April 15, 2010

The enclosed documents are in response to the deficiencies and requests for clarification of Essential Isotopes application for NRC license control number 318475 and 318478. I hope that you find the responses satisfactory, if not please call me for further clarification

Essential Isotopes – Cyclotron Deficiencies Control # 318478

6. Figure 1.

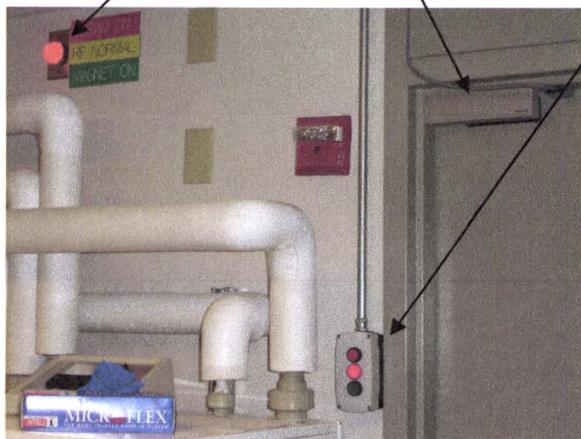
- 6. Describe the use of alarming system that is employed in the cyclotron room that would be activated in the event of entry into the cyclotron room while the unit is in operation. Describe the interlock system and how with works.**

A description of the cyclotron vault alarm and interlock system is attached.

2. The vault door is magnetically locked. (figure 1) This lock can only be disengaged when the systems powering the cyclotron are turned off. There is an indicator light in the electronics room that indicates the cyclotron status. (figure 1) The light designations are as follows:

4. There are two interlocks in the vault itself. These must be manually armed before leaving the vault before the final interlock can be engaged. The final interlock is outside the vault door (figure 1.) and must be engaged before the cyclotron can be powered up.
